DAB COMMENTS – Attention Homes proposal

MEETING DATE: Dec. 14, 2016
ADDRESS: 1440 Pine, 1424 Pine, 1414 Pine, 1406 Pine, 2132 14th, 2124 14th, 1421 Spruce, and 1443 Spruce)
DESCRIPTION: Proposal to develop an existing parking lot on the corner of Pine Street and 15th Street on the First United Methodist Church site (including the following properties within RH-2 [Residential High – 2] zoning district: 1440 Pine, 1424 Pine, 1414 Pine, 1406 Pine, 2132 14th, 2124 14th, 1421 Spruce, and 1443 Spruce) with a three-story 30,000 square foot building containing 40 affordable rental units, associated common area and office space and 95 total parking spaces. The units associated uses would be managed by Attention Homes, a non-profit agency, and are intended for homeless young adults between the ages of 18 and 24 years old who are in need for supportive services in order to address underlying issues associated with their homelessness.
APPLICANT: Jeff Dawson, Studio Architecture

A Site Review application is anticipated in January 2017. The applicant is requesting feedback on the general massing and materiality of the building before submitting the application.

SCHEMATIC SITE PLAN
 1" = 30' - 0"

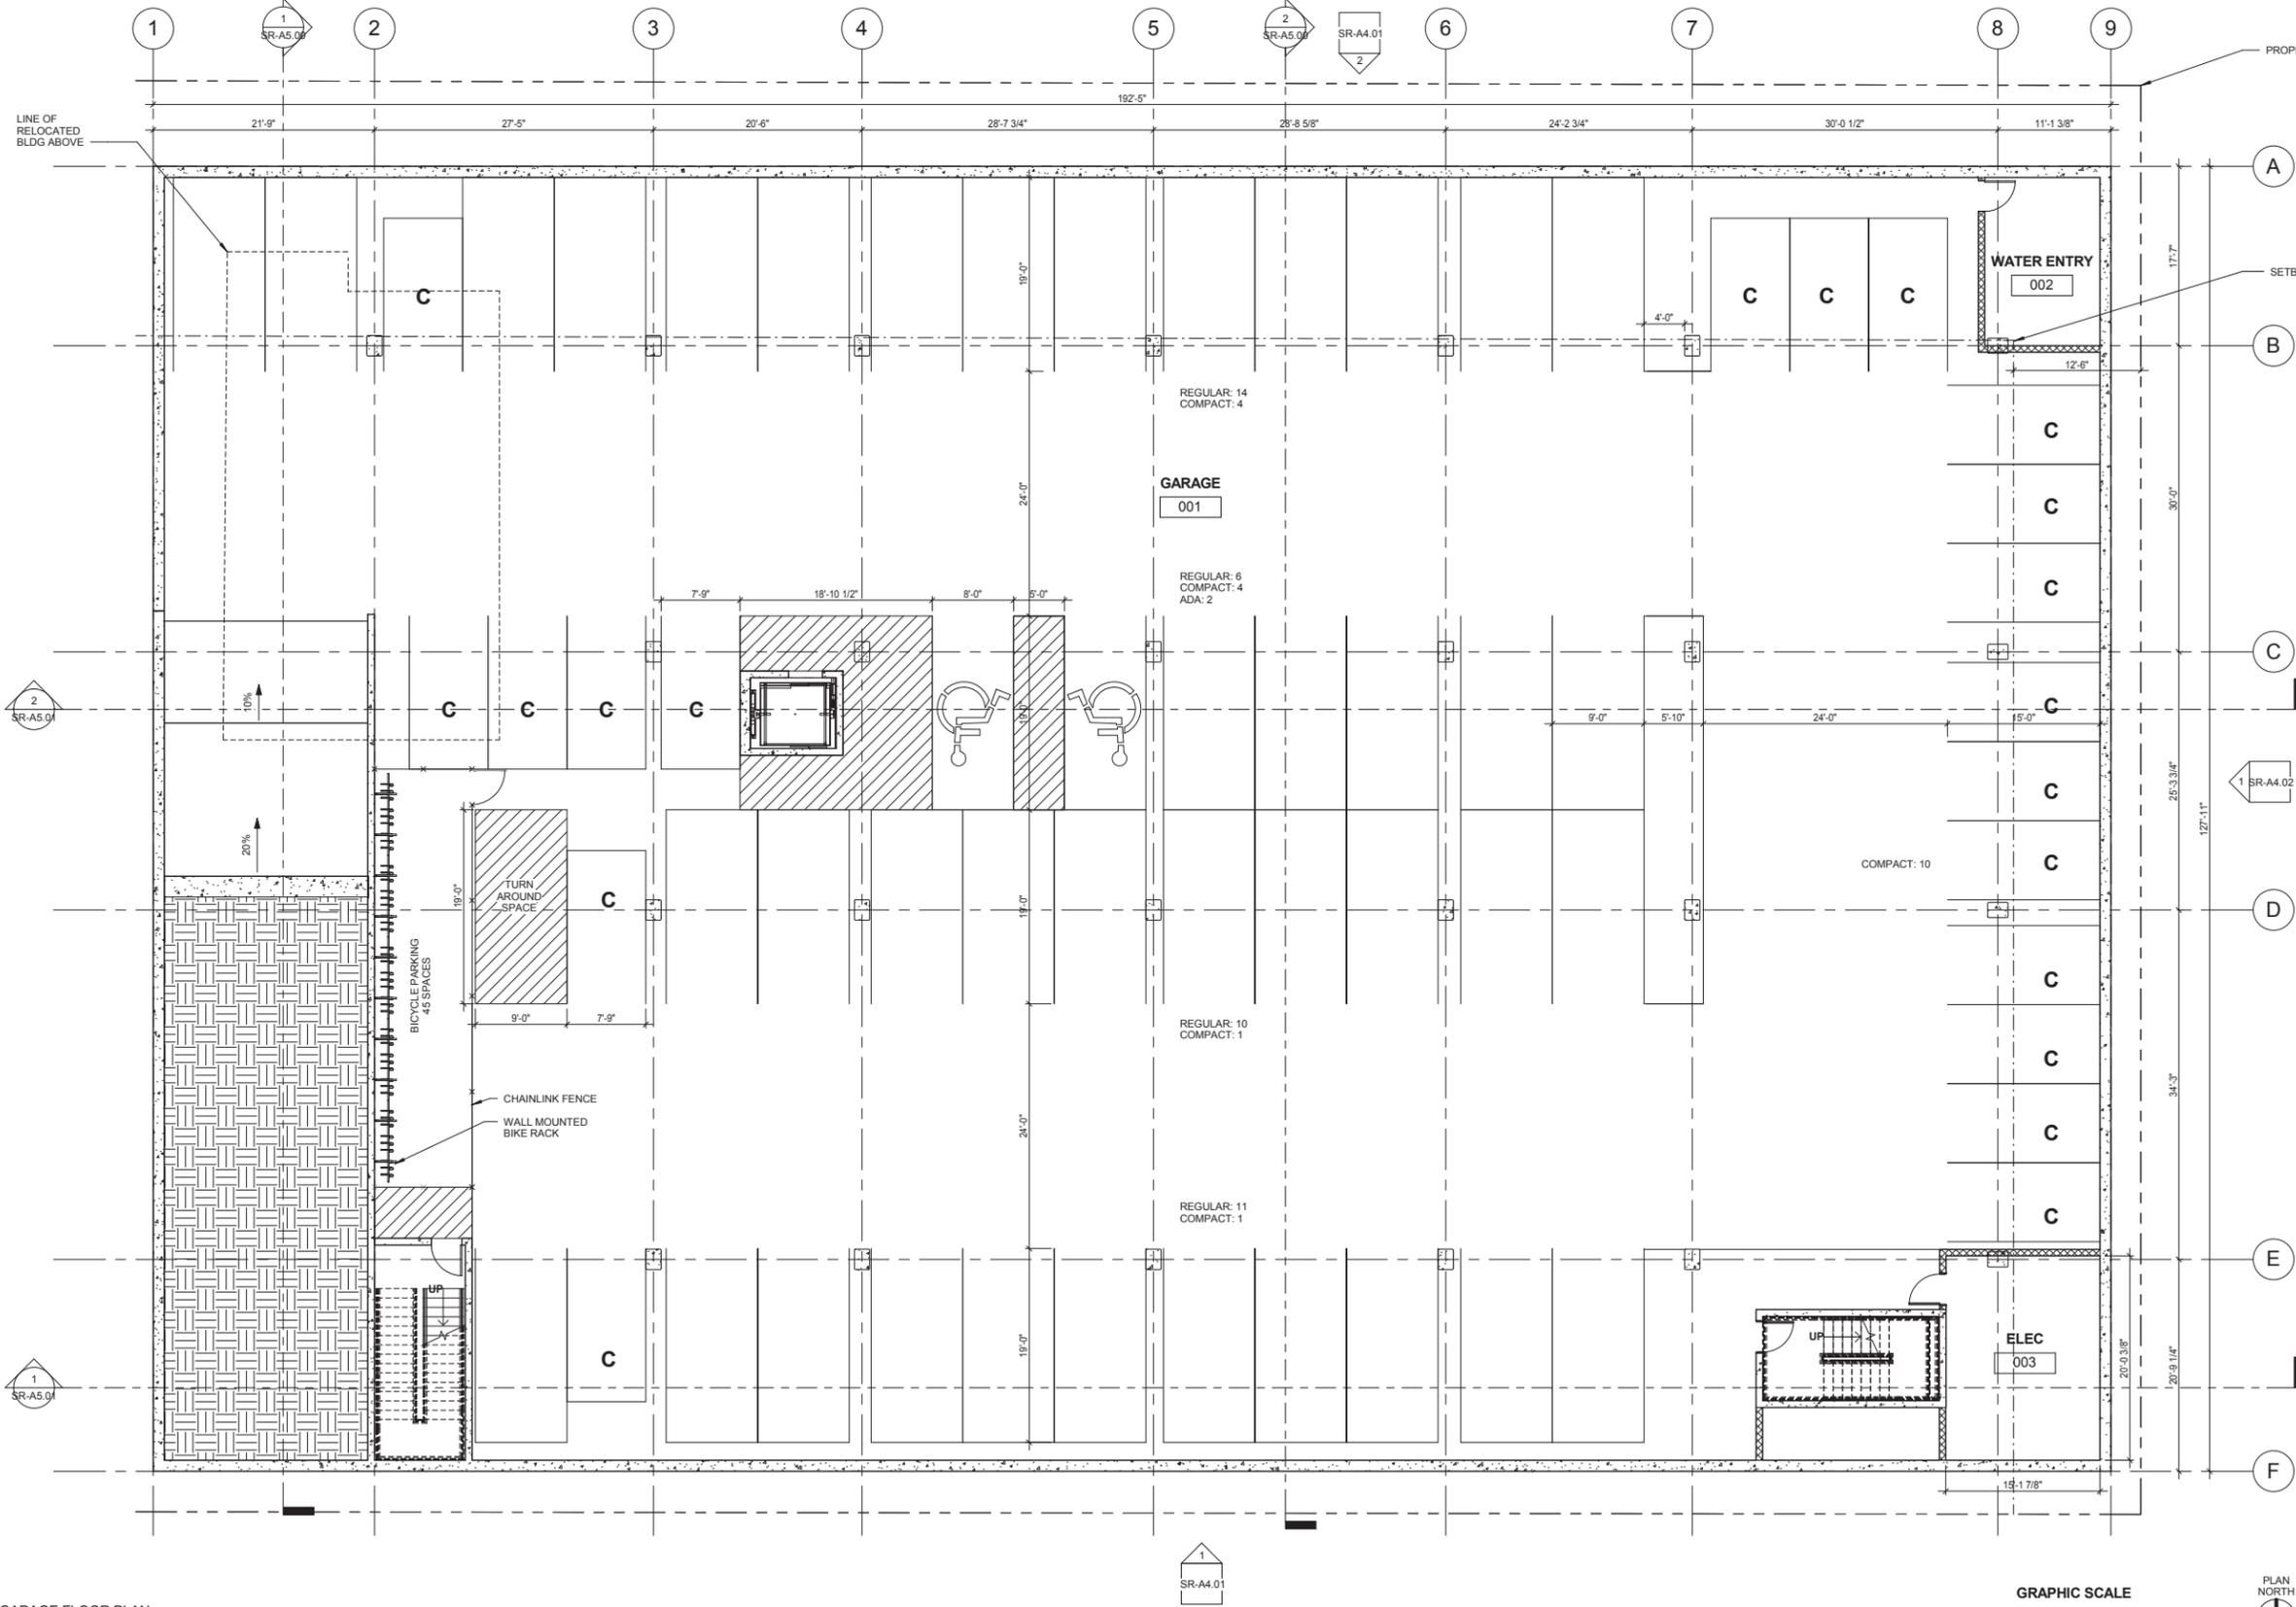
Staff finds that with the entire block being owned by the church, the alley would be an opportunity for an enhanced alley with special paving and surface treatments to encourage pedestrian and vehicular use. This is something that should be explored prior to Site Review application.

Alley Trees Required: 15
 Alley Trees Provided: 3
